**CAMECO RESOURCES
CROW BUTTE OPERATION**

Annual Report of Changes, Tests, or Experiments
License No. SUA-1534
Docket No. 40-8943

Crow Butte Resources, Inc. (CBR) d/b/a Cameco Resources – Crow Butte Operation (CBO) is providing this annual report summarizing the changes, tests or experiments made under License Condition 9.4 of SUA-1534 during calendar year 2016. This report is made in accordance with the reporting requirements contained in License Condition 9.4 (E).

Figure 5.1-1: Crow Butte Resources Organizational Chart

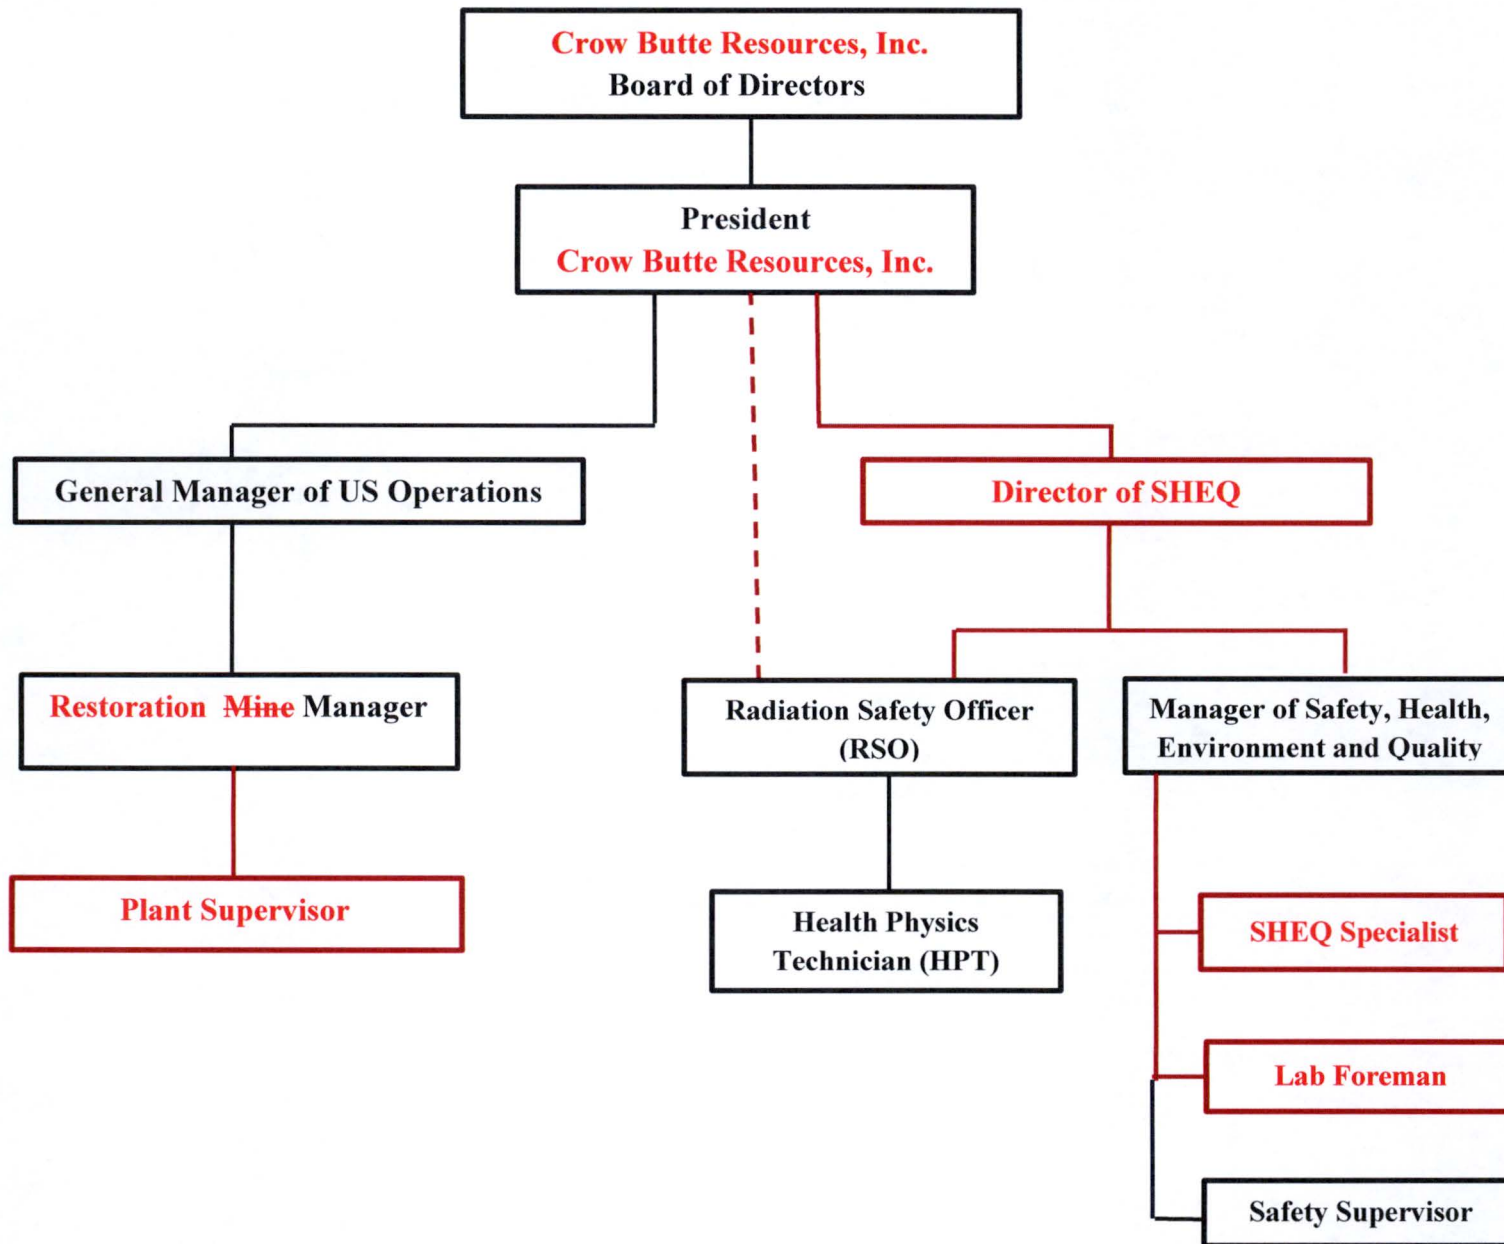
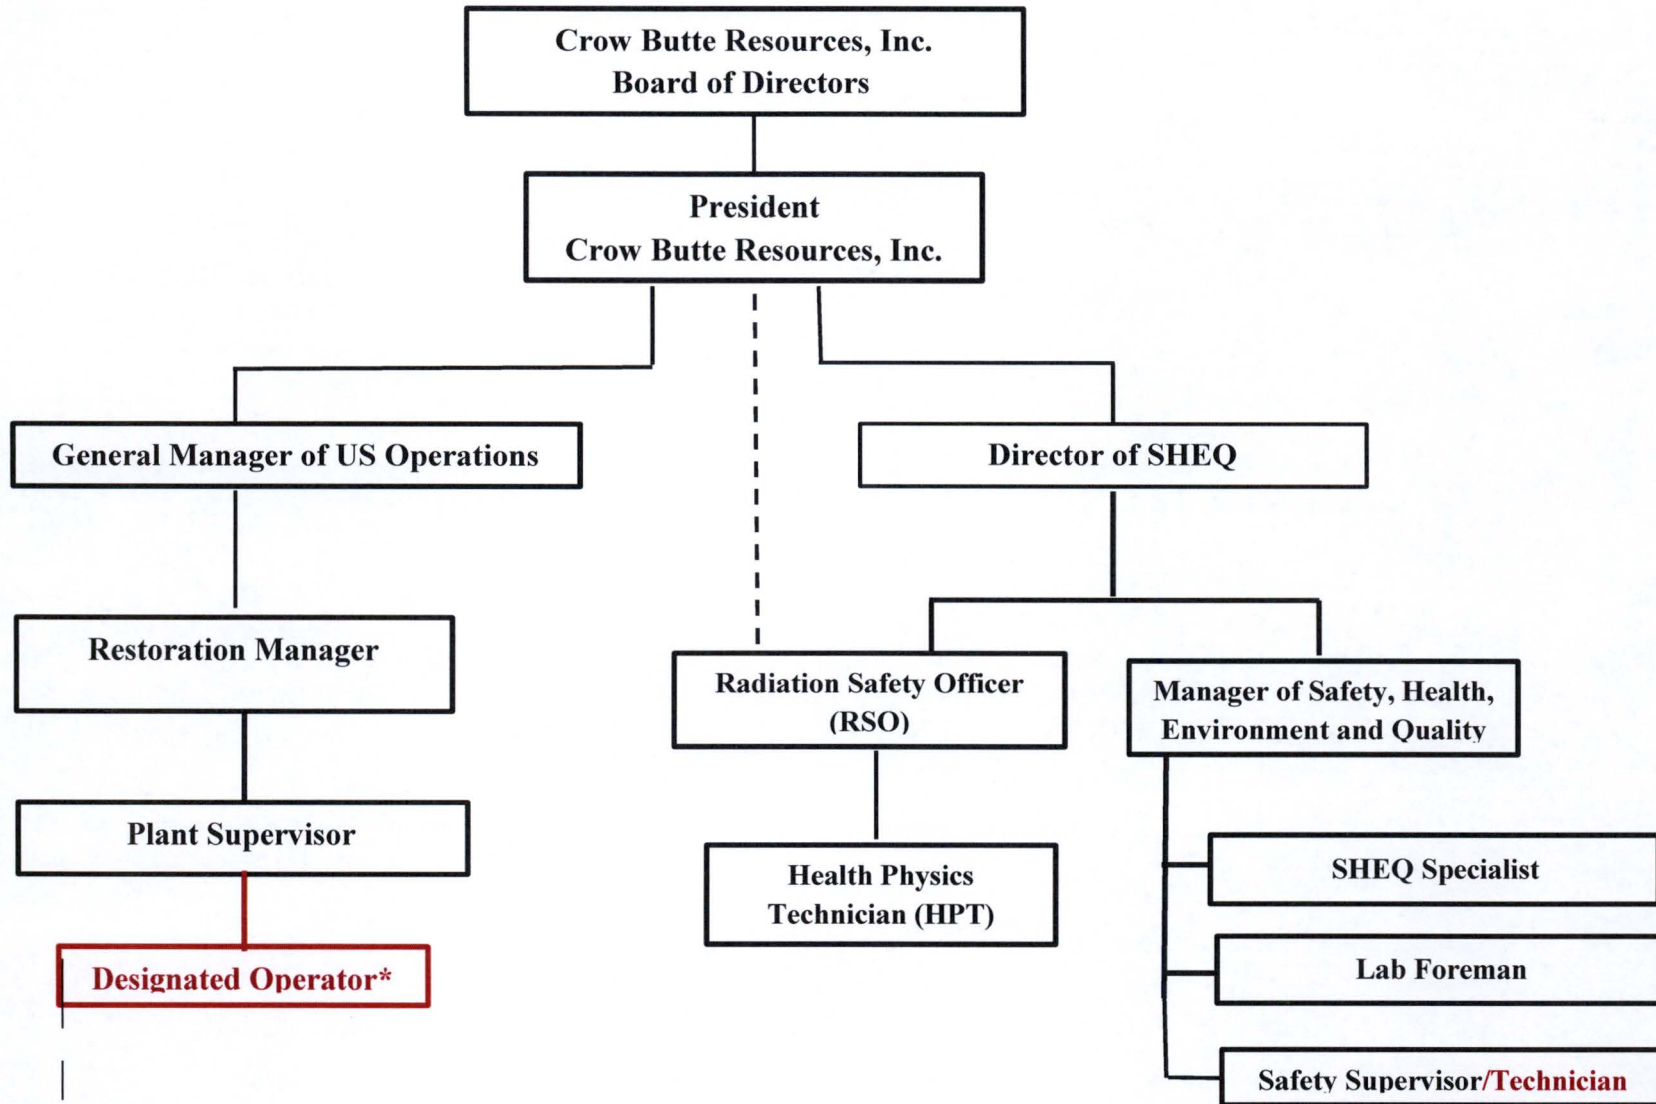
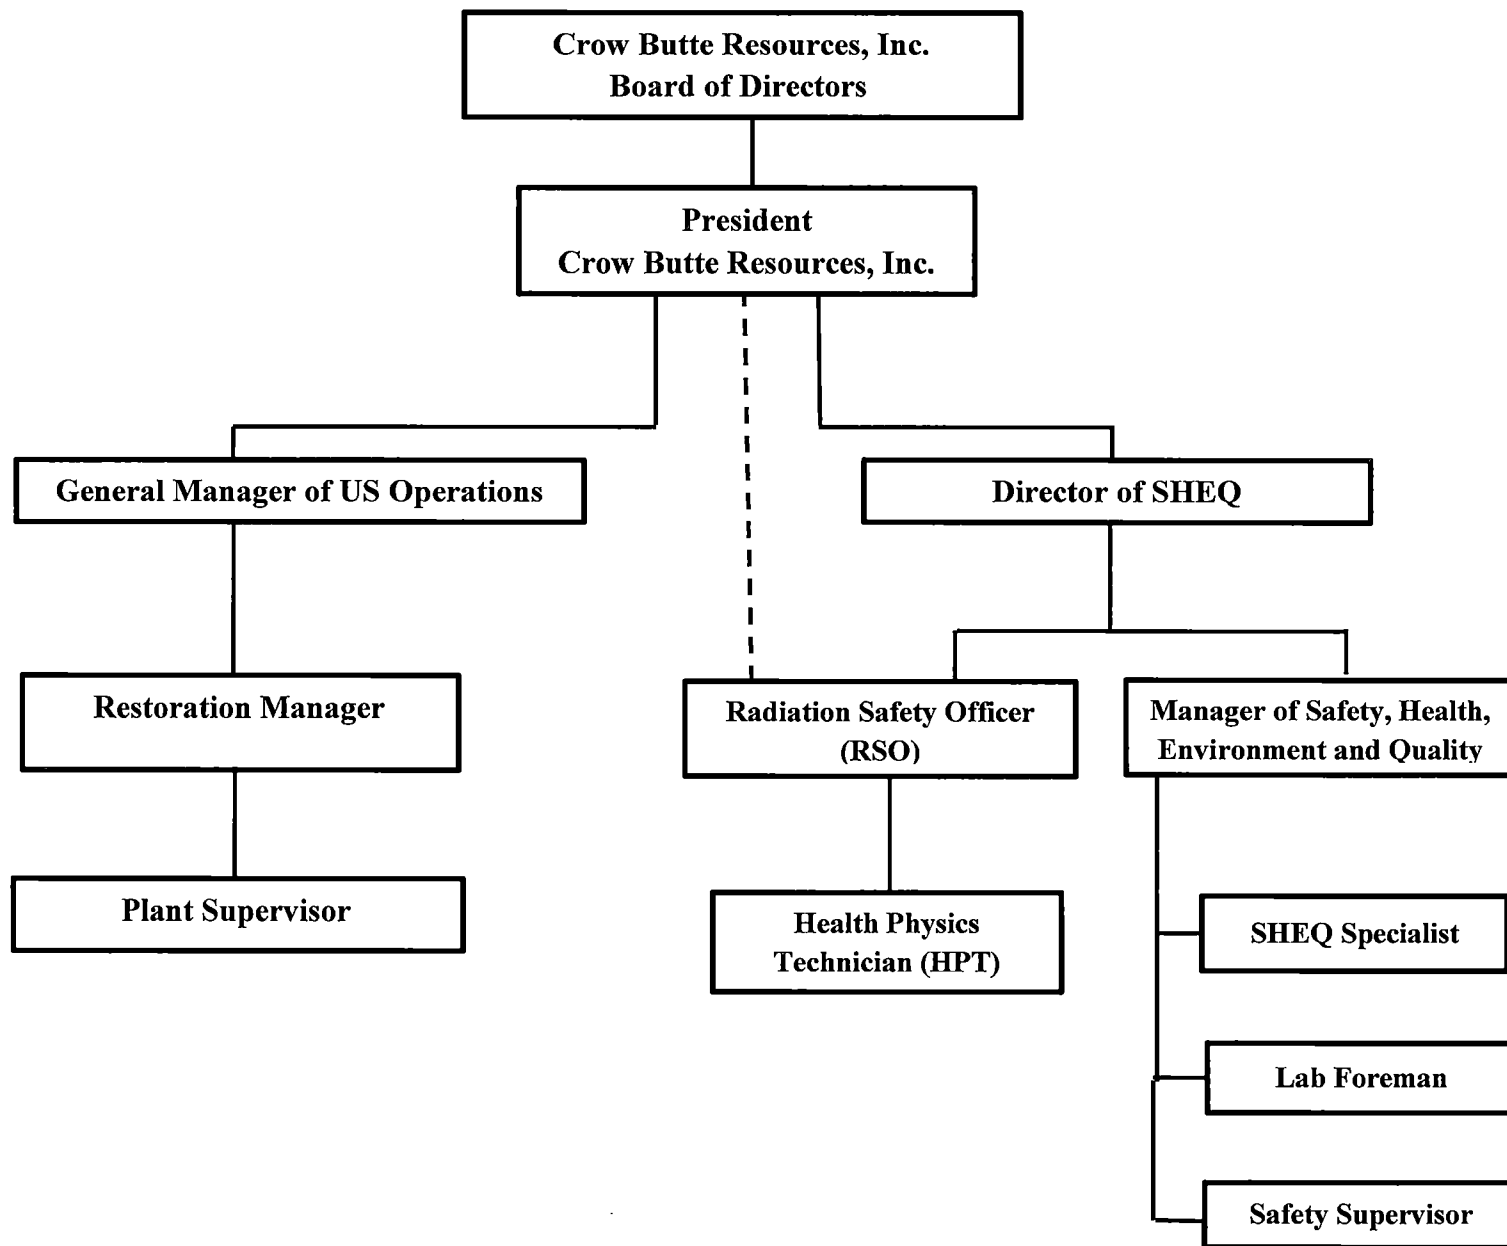
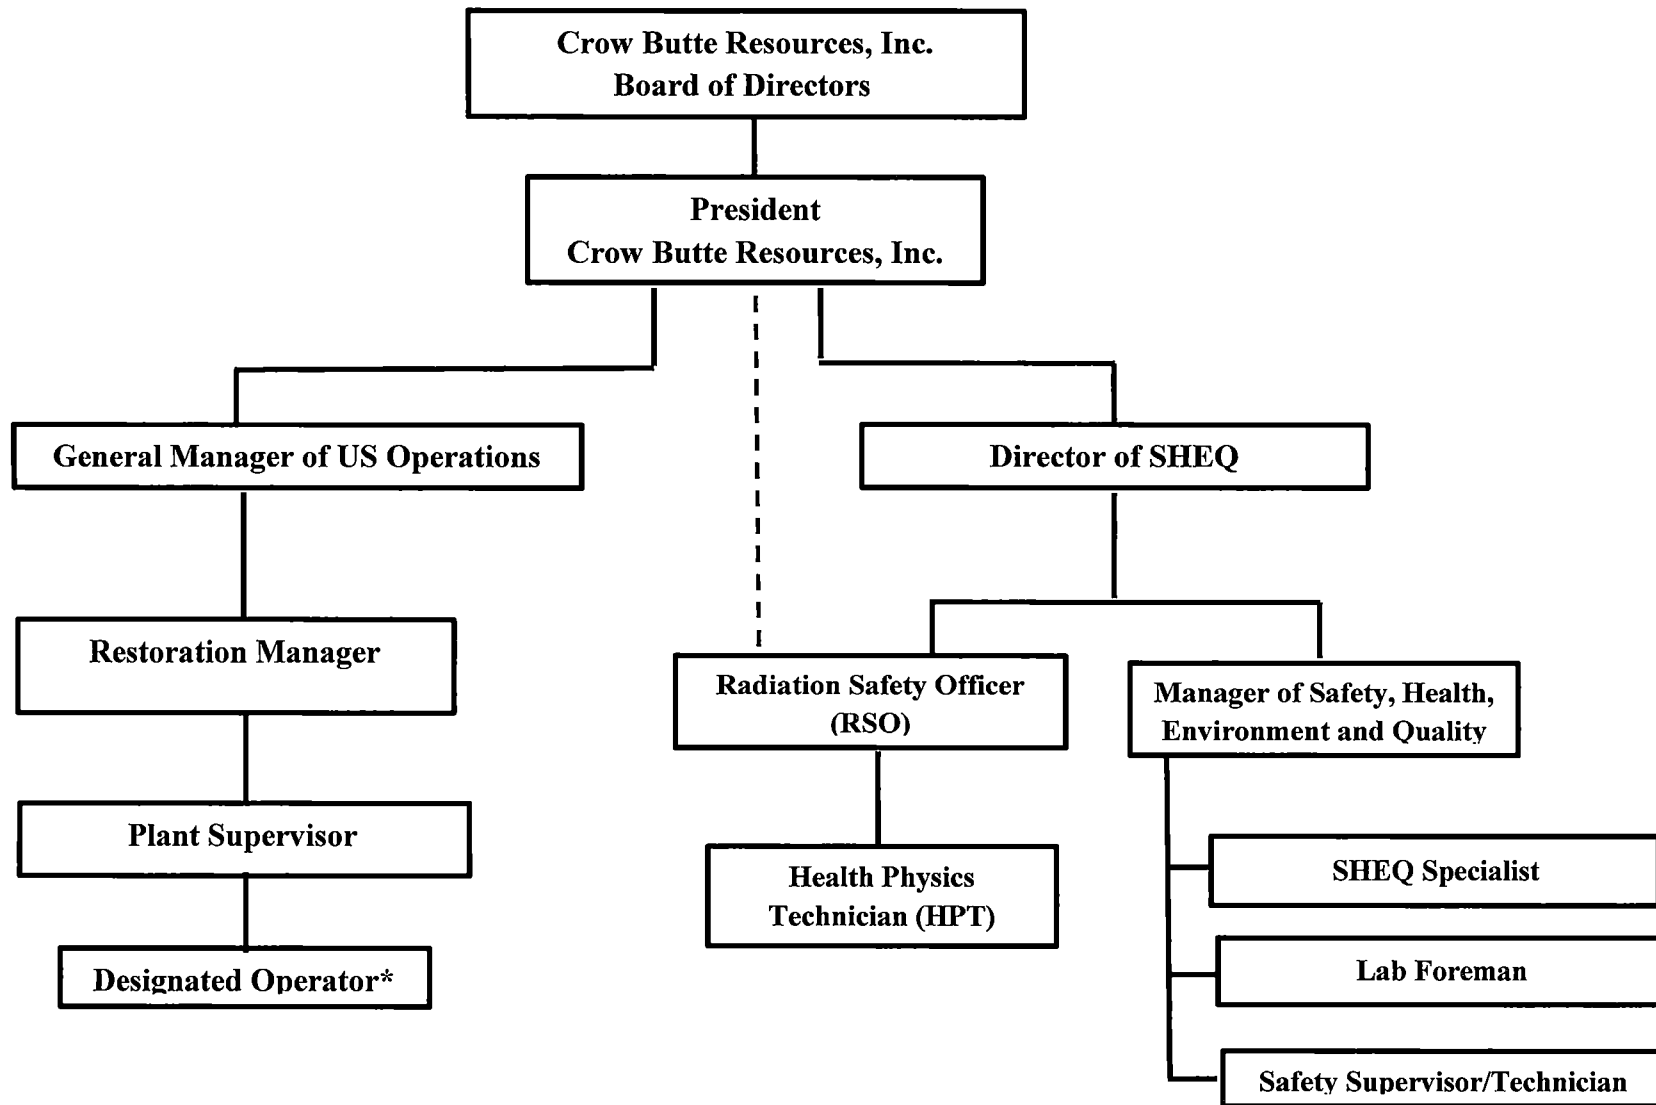
An organizational change has been made that directly and indirectly affects the reporting responsibilities of the radiation safety staff. The direct reporting of the Radiation Safety Officer (RSO) has been changed as shown in the revised Figure 5.1-1 from the approved License Renewal (November 2014). The RSO currently reports to the Mine Manager, with the organizational change, the RSO will report directly to the Director of SHEQ. The indirect reporting for the RSO has been changed as shown in the revised Figure 5.1-1 from the approved License Renewal (November 2014). The RSO currently reports indirectly to the General Manager of U.S. Operations. With the organizational change, the RSO will have an indirect reporting requirement to the President.

A follow-up to this SERP is being conducted to include the title "Designated Operator" in the organizational chart (Figure 5.1-1). Employee's that meet the training qualifications to be classified as a "Designated Operator", will report to the Plant Supervisor.
